## Addendum #2 – Elite Hall Addition

Re: Revision to Bid Documents

# ELITE HALL ADDITION 98 WEST MAIN ST HYRUM, UTAH

S501

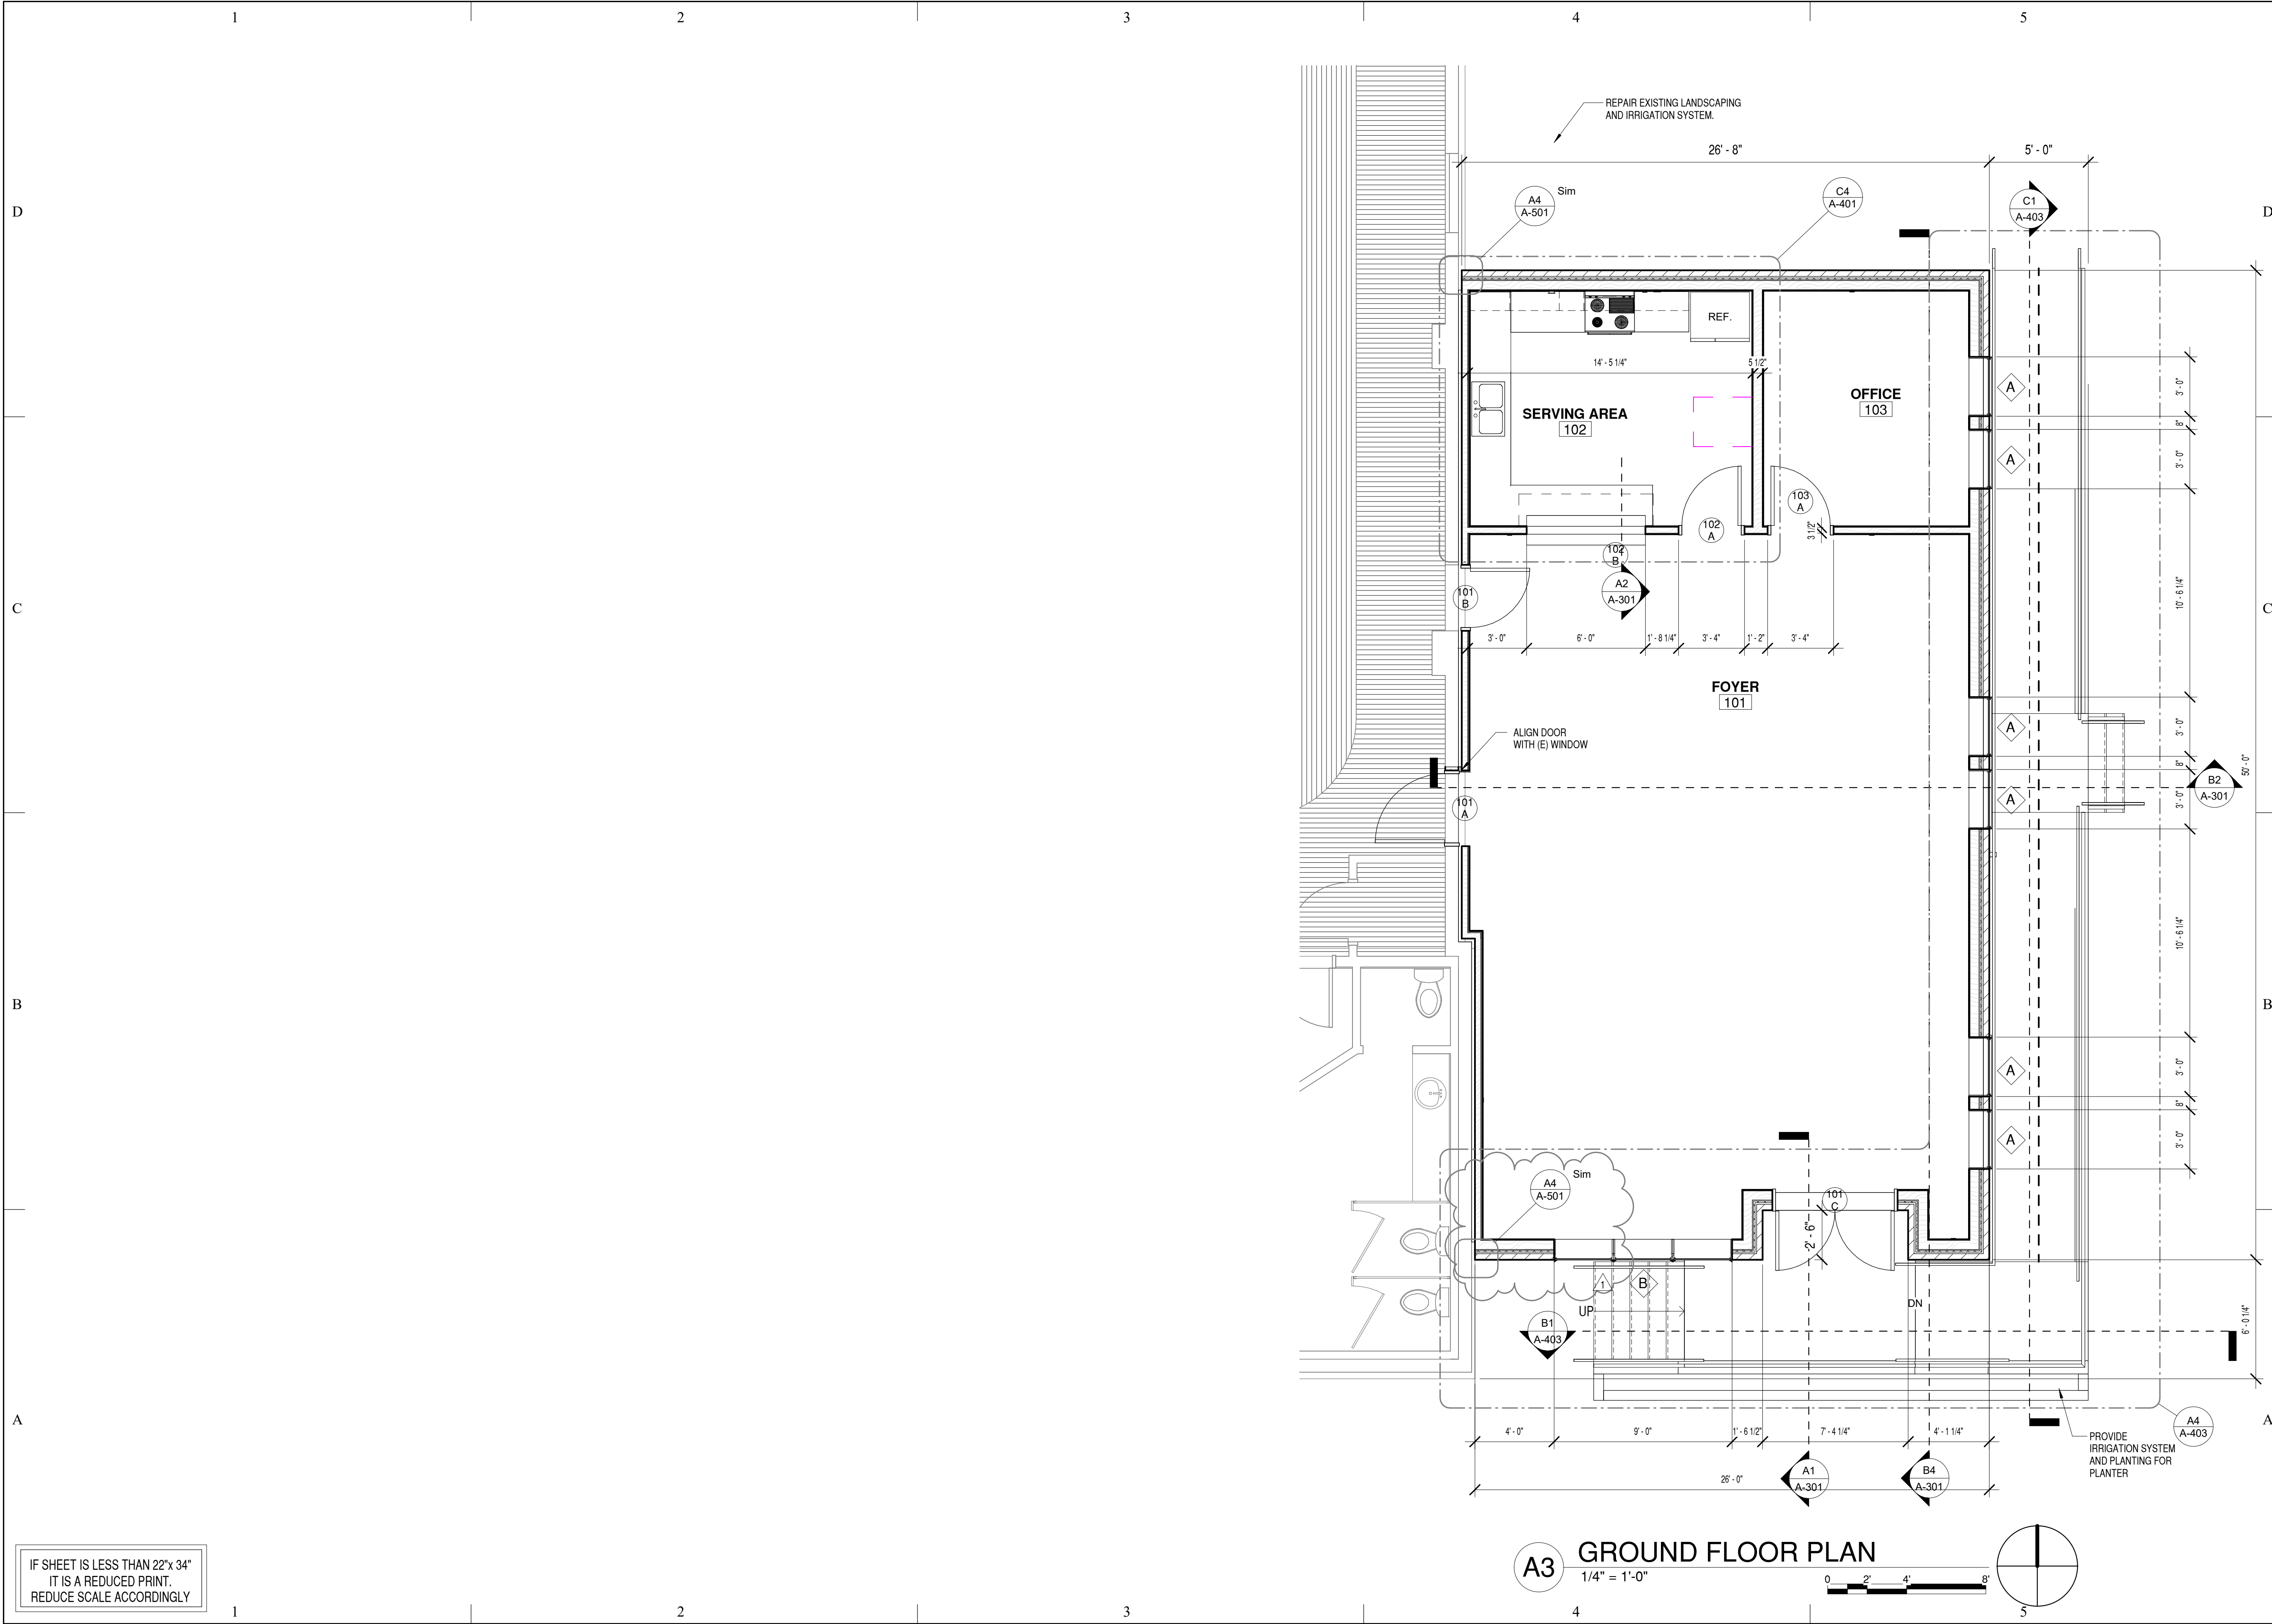
6. There aren't any details specifically calling for wood or metal stud framing for the interior soffit areas. Please clarify if wood is desired or if metal stud framing will work.

10. Is there a brick ledge in the foundation wall on the north side of the building?

Response: Wood framing, see revised A1/A-301, 1/S103, and 15/S501.

Response: See revised Detail 3/S-501 and C4/A501 for brick ledge at widened foundation wall for supporting the brick.

**B1 RAMP SECTION**  
3/8" = 1'-0"

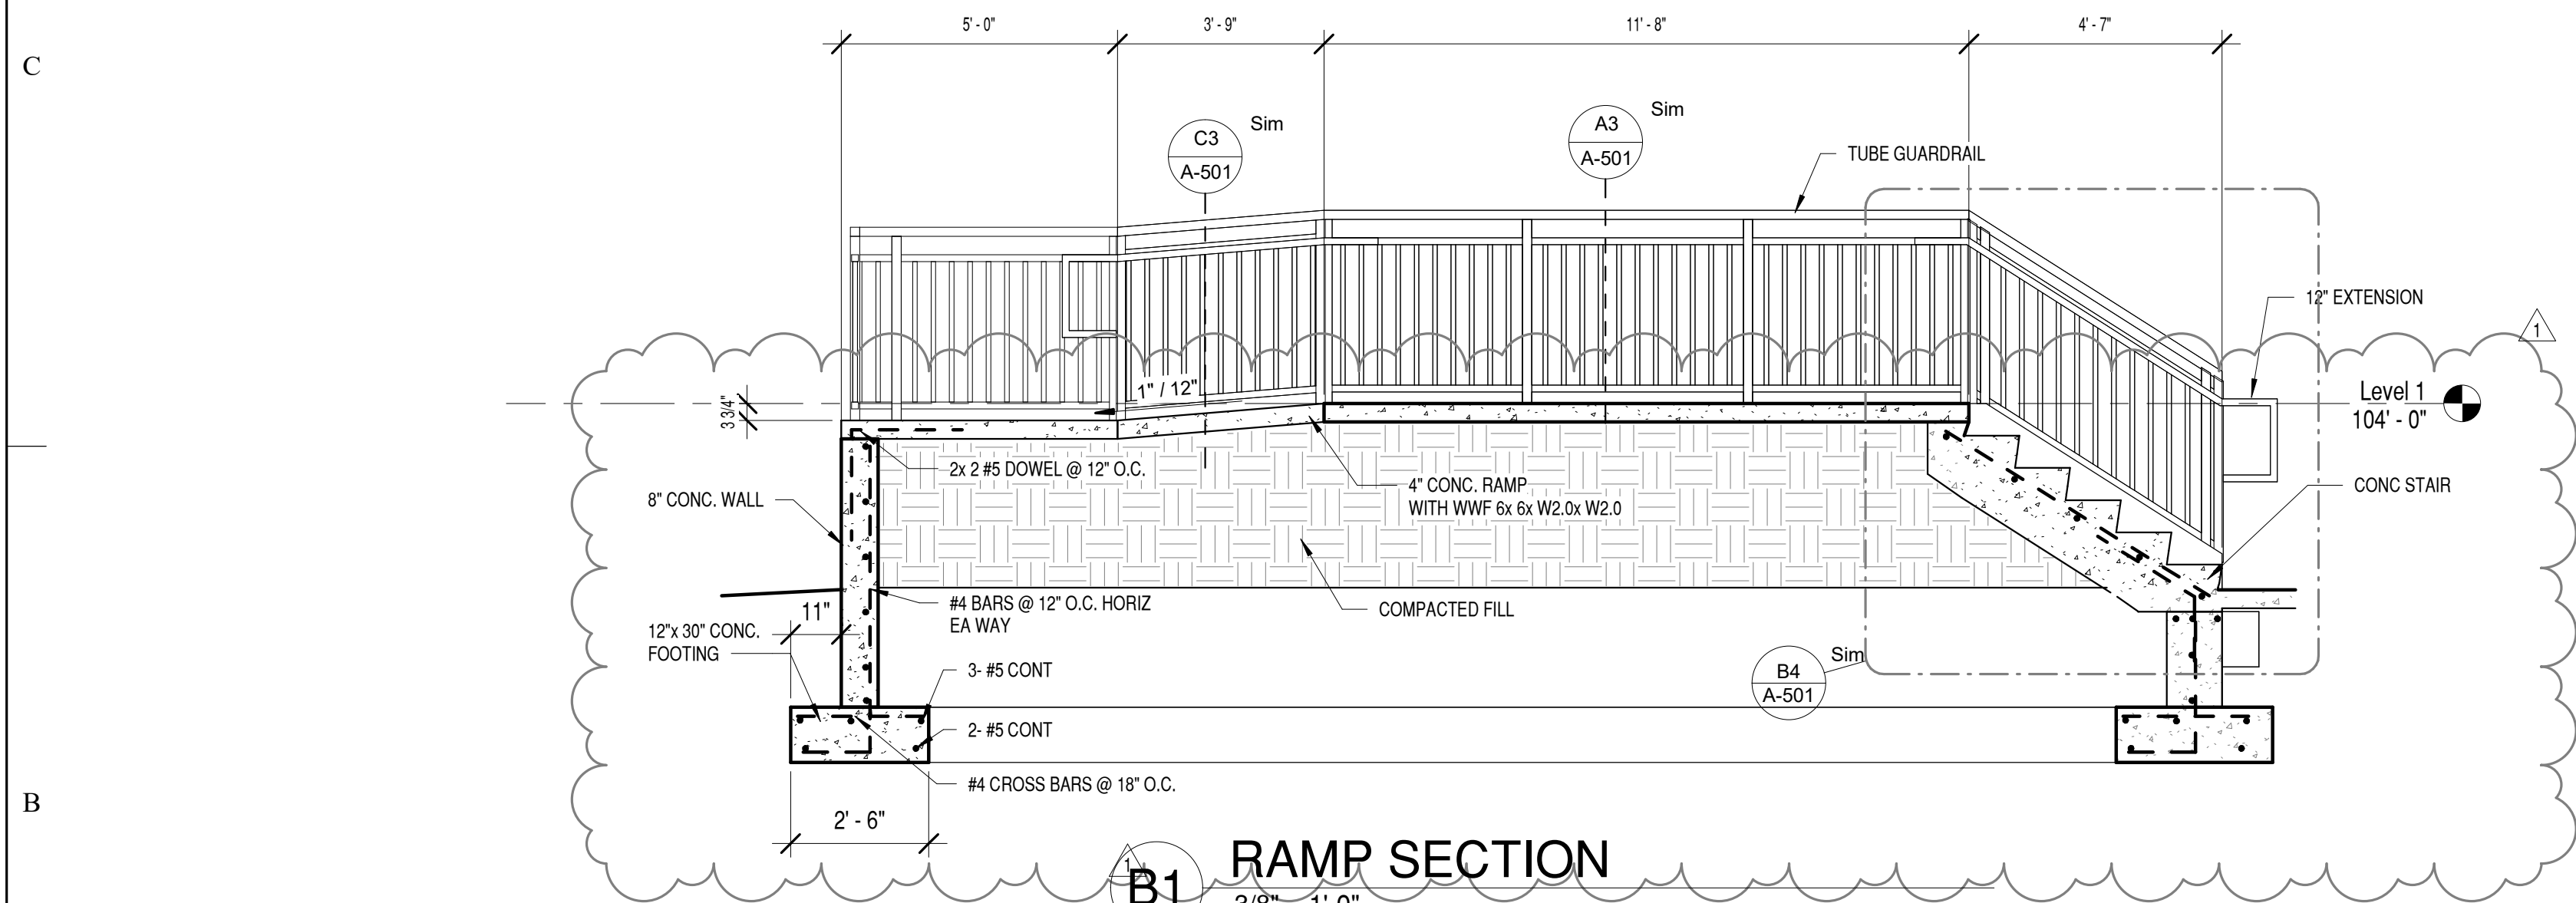
14. B1/A403 calls for fiber reinforced concrete at the exterior concrete ramps, but there isn't a specification. What is the desired intent? That same detail also shows a footing and stem wall under the bottom stair, but there isn't any call out for those on the structural plans. Please clarify.

Response: See revised B1-C1/A403, revised reinforcing to WWF for ramp. See revised B1-C1/A403, B4/A501 footings for retaining wall, stair and ramp.

A-501

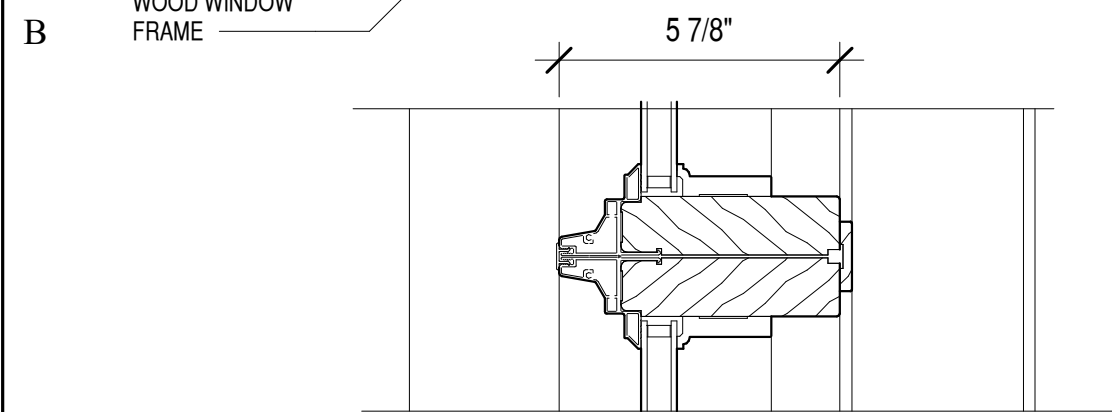
13. There is some expansion material called out between the existing building and the new addition, but no specification for it. Please provide.

Response: The expansion joint cover for the wall is called out on A4/A501, and for the roof is C4/A502. Parapet cap to extend to existing building and be flashed/sealed.
